Re: Initial Submission Review – Enclave at Saddle Rock – Site Plan
Application Number: **DA-1074-15**
Case Number: **2019-4016-00; 2019-3048-00**

Please find included comment responses from the 2nd review comments dated August 31, 2021. Our comment responses are included in *red italics*.

THE ENCLAVE AT SADDLE ROCK GOLF CLUB NORTH SITE PLAN

DRAWING: SITE PLAN

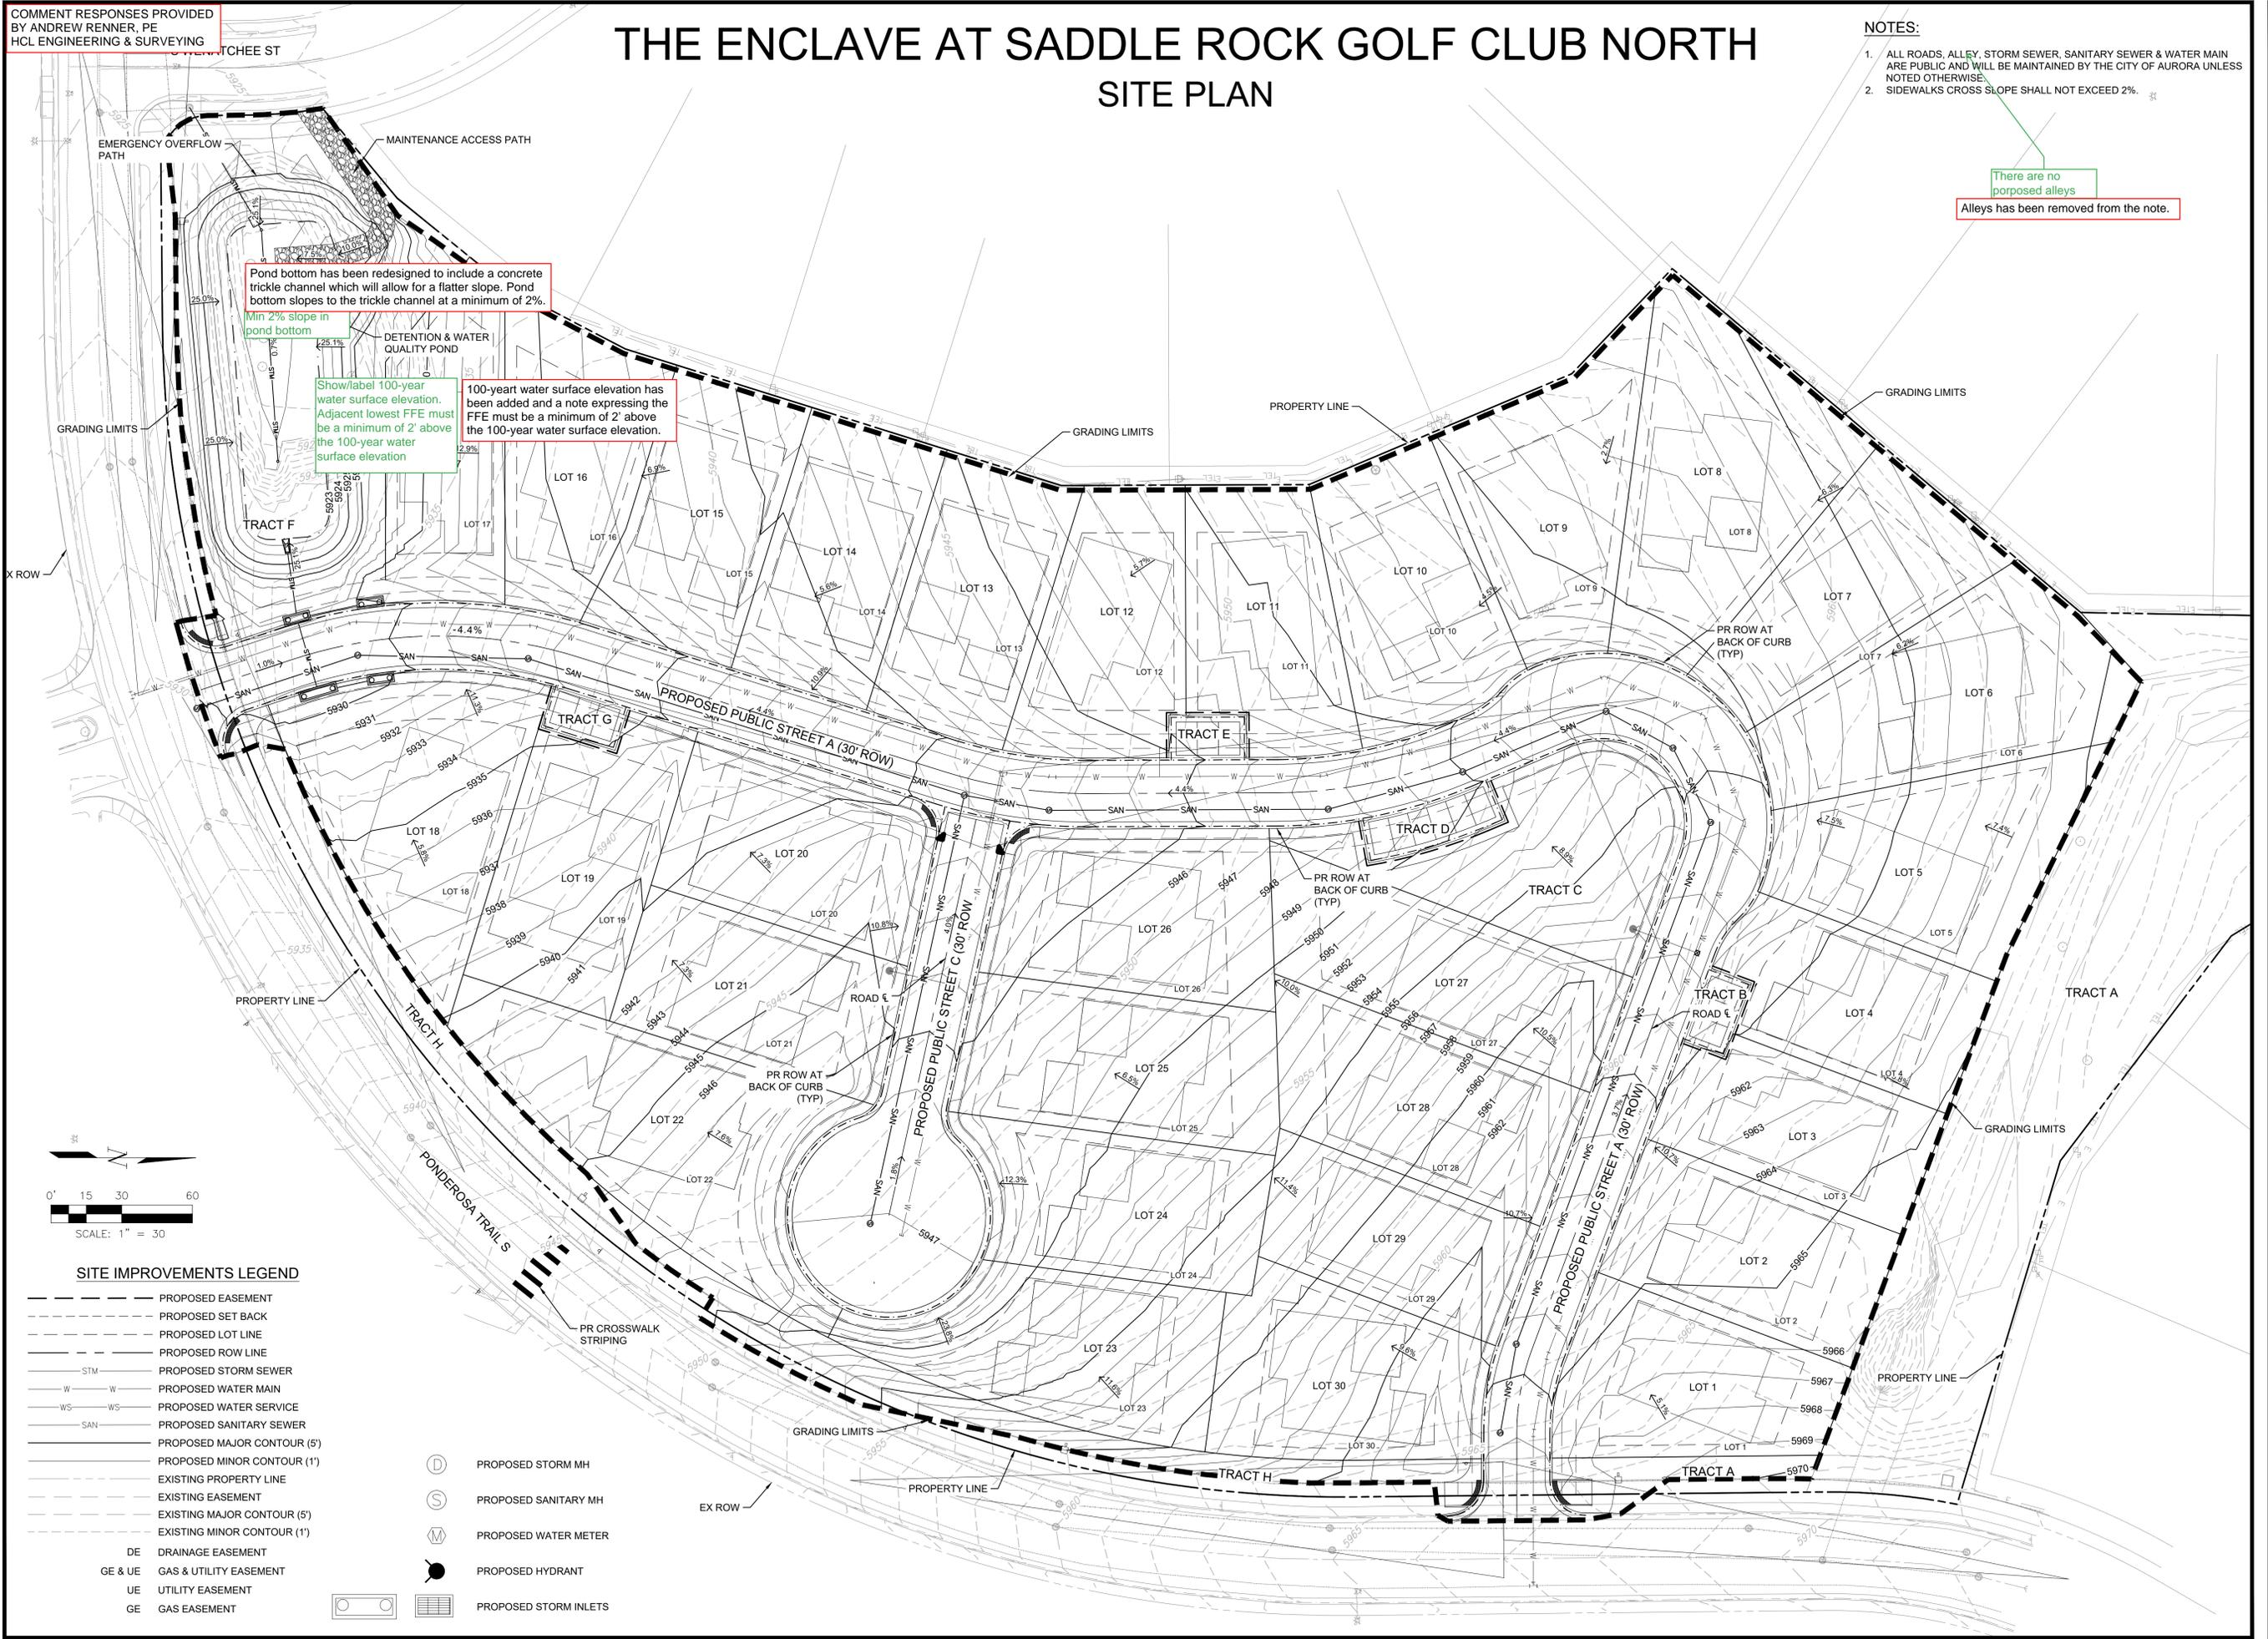
Show/label 100-year water surface elevation. Adjacent lowest FFE must be a minimum of 2' above the 100-year water surface elevation

100-year water surface elevation has been added and a note expressing the FFE must be a minimum of 2' above the 100-year water surface elevation.

PROJECT:	SADDLE ROCK
DRAWING:	UTILITY PLAN
CLIENT:	CITY OF AURORA
DESIGNED BY:	SEE SHEET
DRAWN BY:	SCALE: HORIZ: VERT:
CHECKED BY:	DATE:

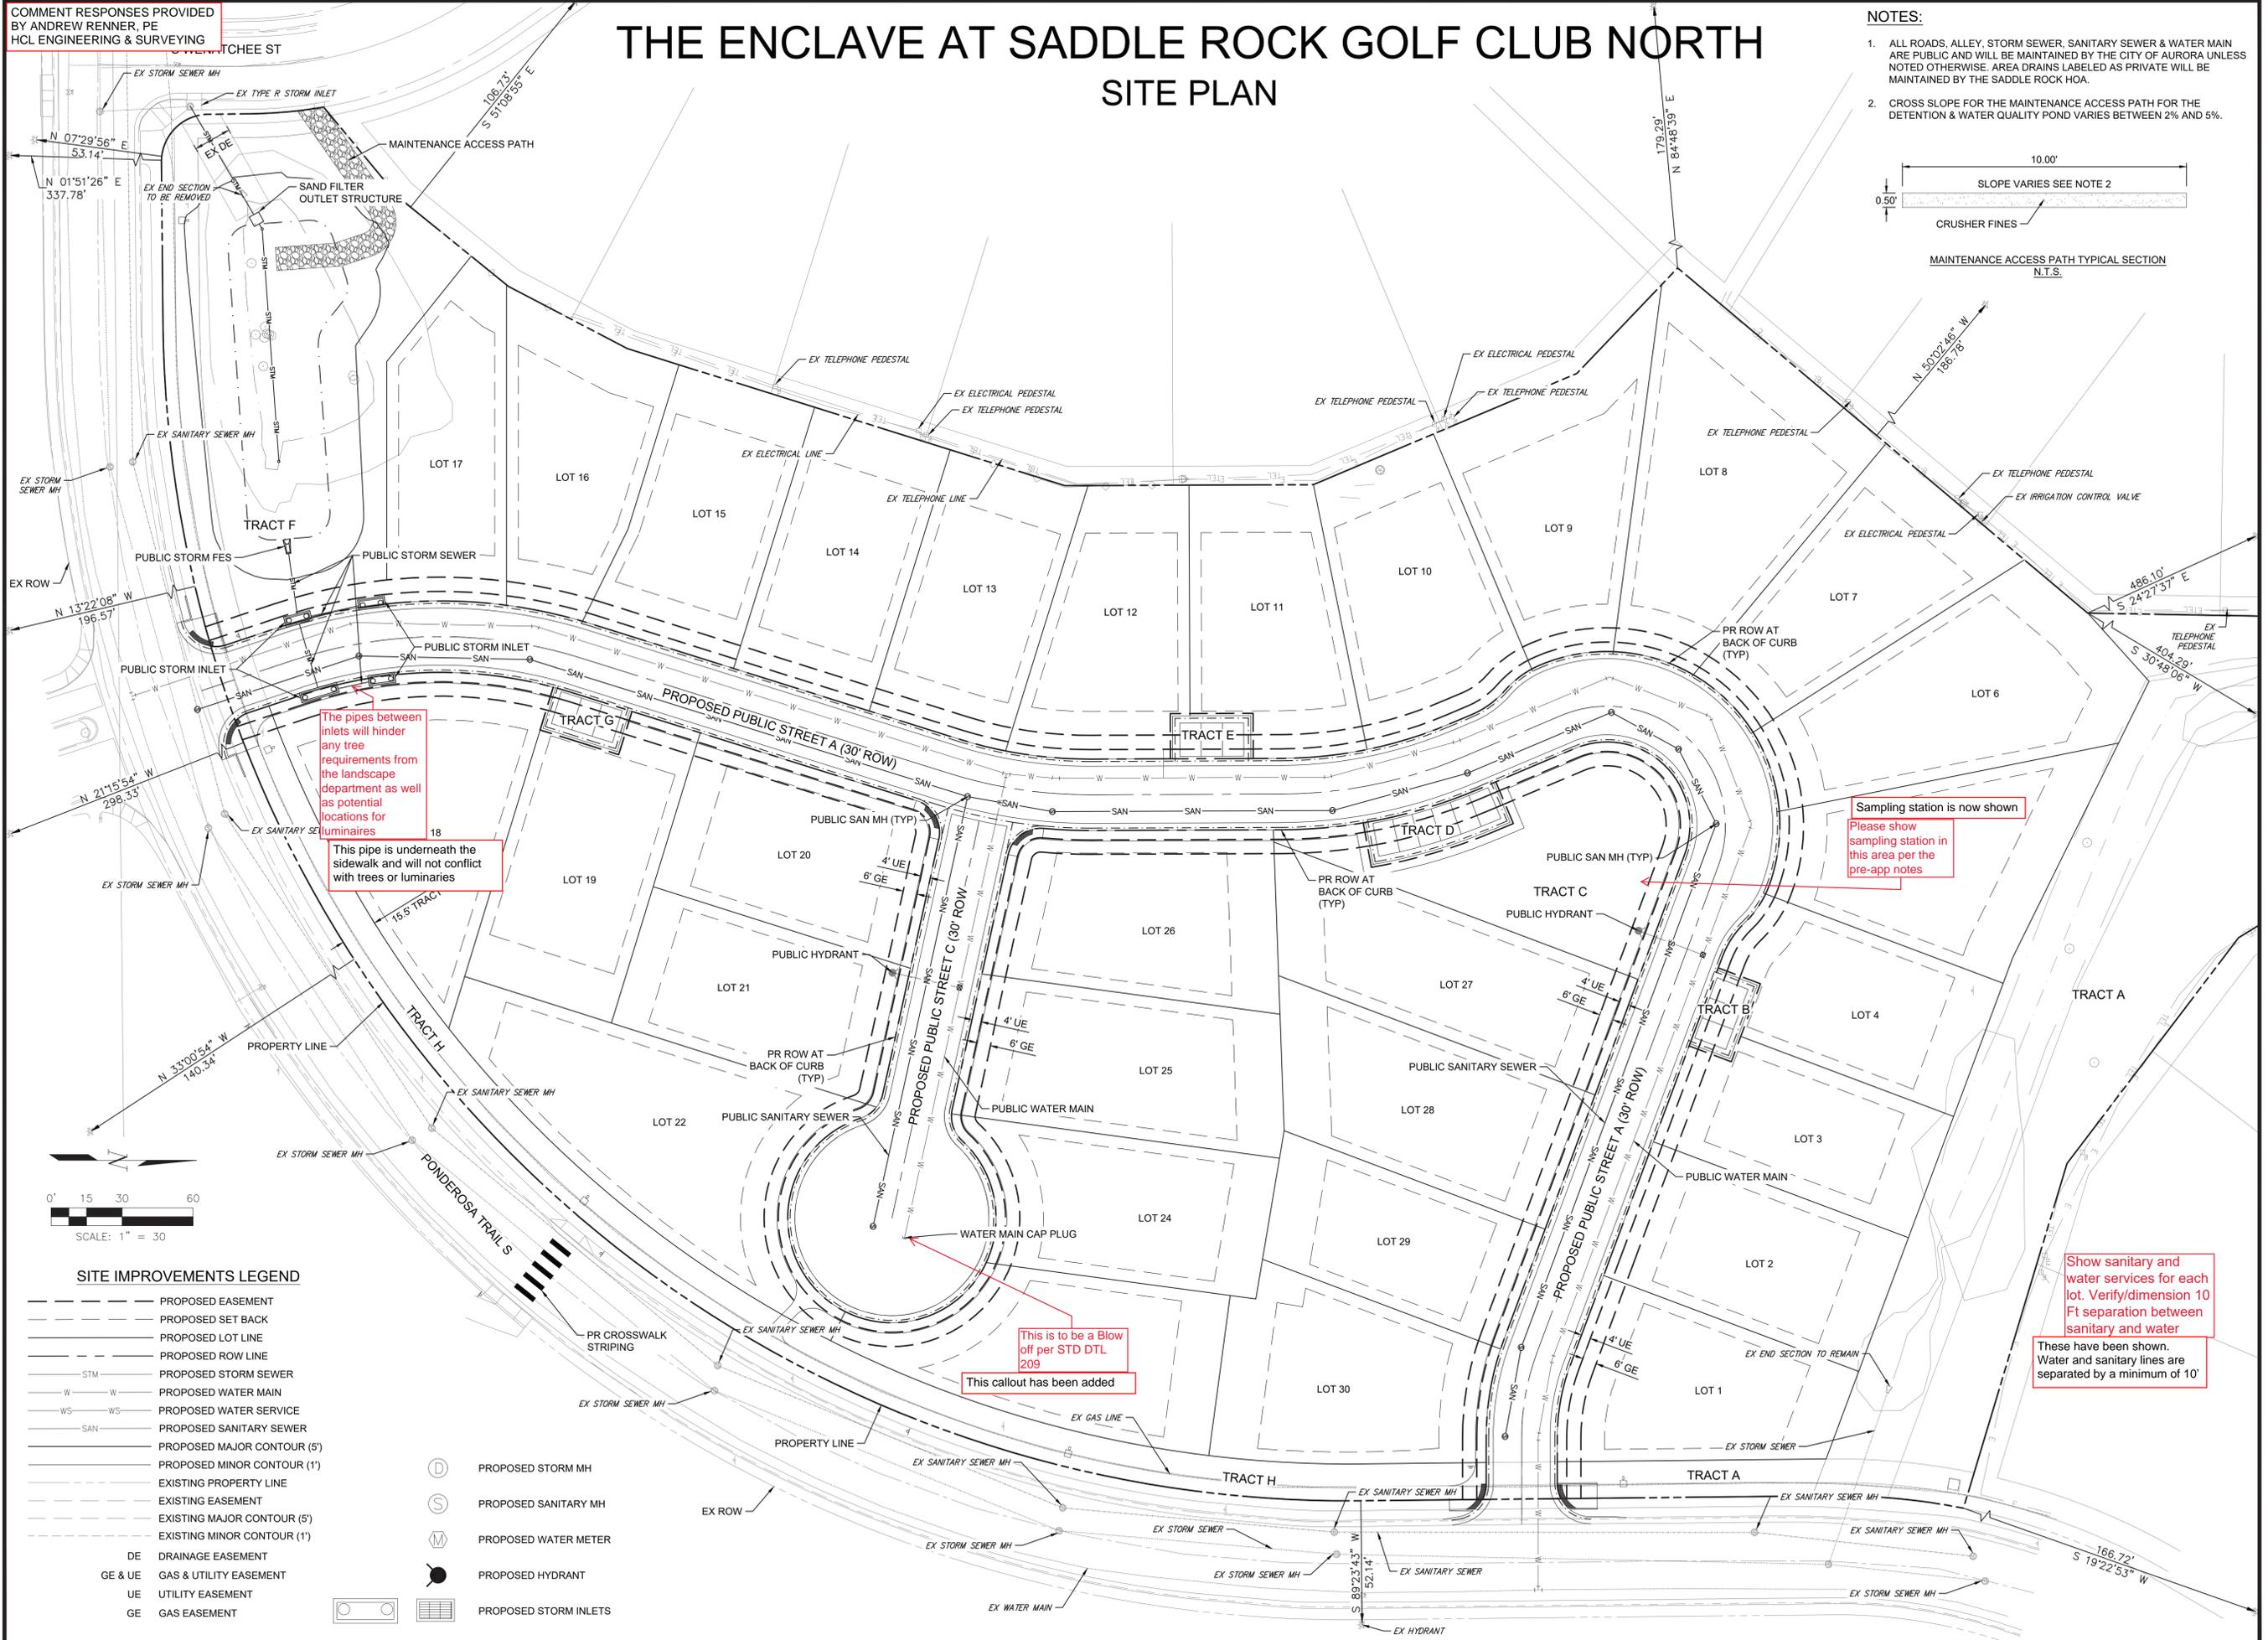
Please show sampling station in this area per the pre-app notes

Show sanitary and water services for each lot. Verify/dimension 10 Ft separation between sanitary and water

This callout has been added

DRAWING: LANDSCAPE PLAN
CLIENT: CITY OF AURORA
DESIGNED BY:
DRAWN BY:
CHECKED BY:

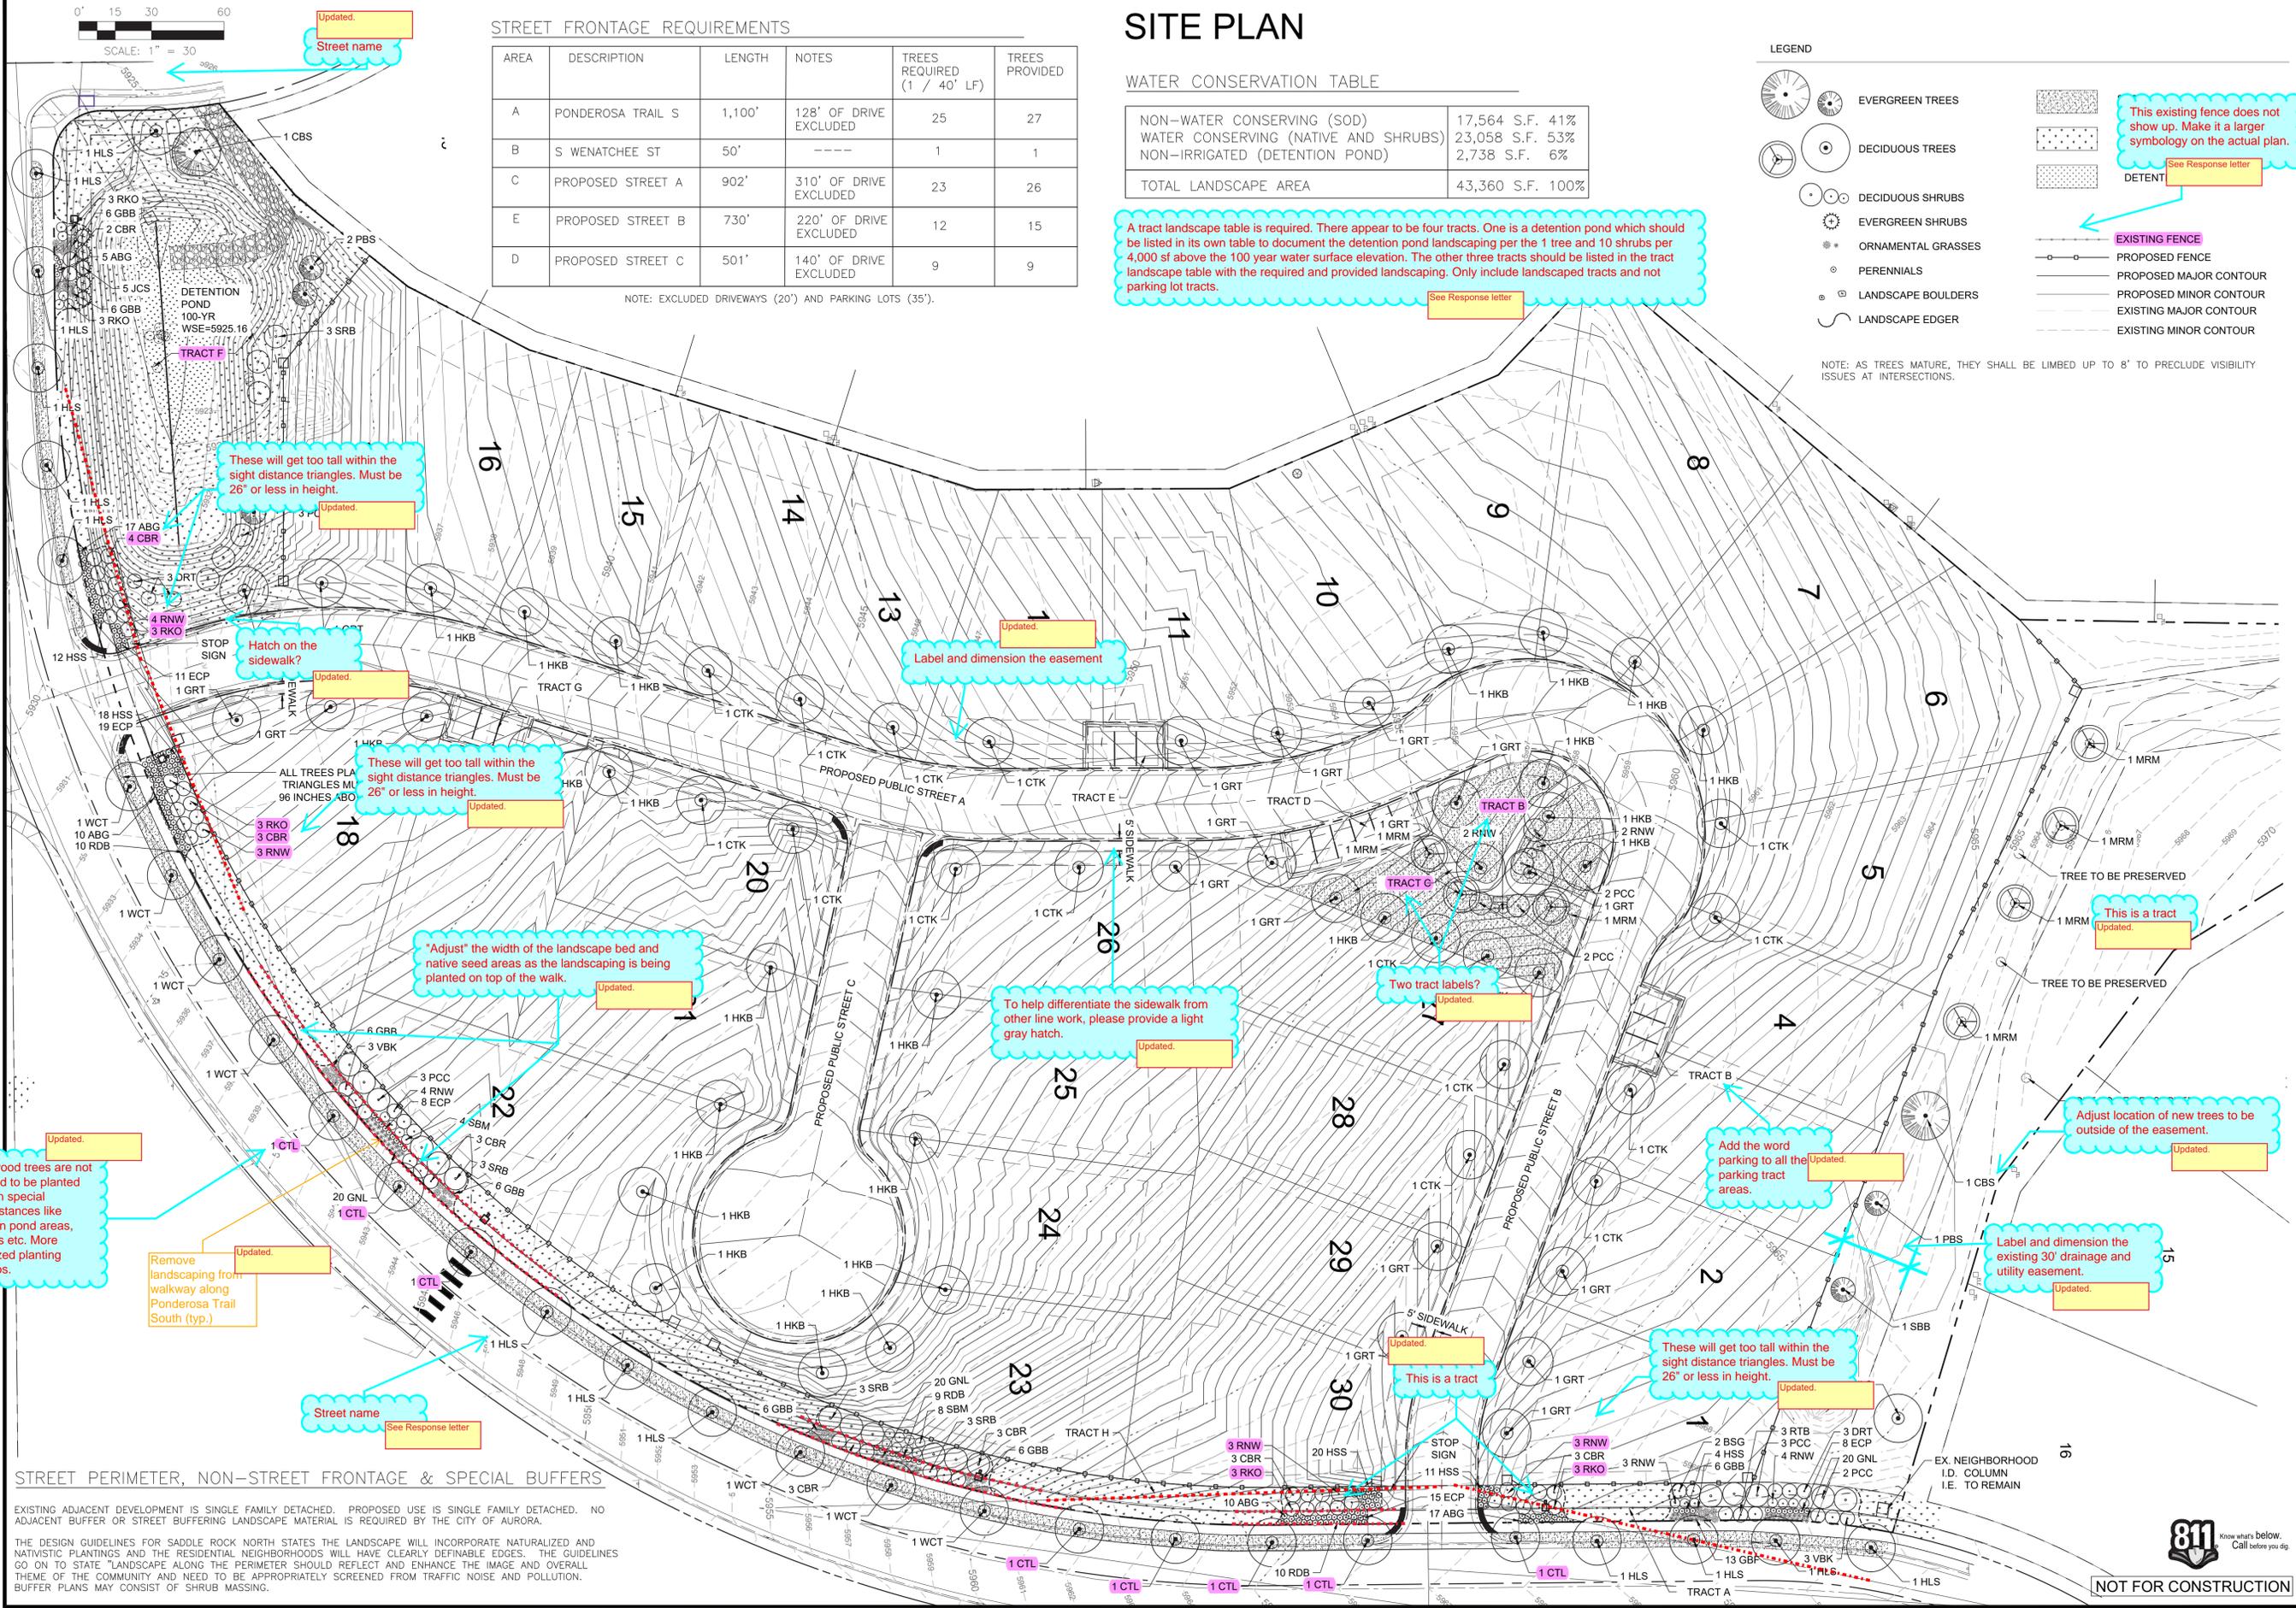
A tract landscape table is required. There appear to be four tracts. One is a detention pond which should be listed in its own table to document the detention pond landscaping per the 1 tree and 10 shrubs per 4,000 sf above the 100 year water surface elevation. The other three tracts should be listed in the tract landscape table with the required and provided landscaping. Only include landscaped tracts and not parking lot tracts.

Cottonwood trees are not permitted to be planted unless in special circumstances like detention pond areas, wetlands etc. More naturalized planting scenarios.

Remove landscaping from walkway along Ponderosa Trail South (typ.)
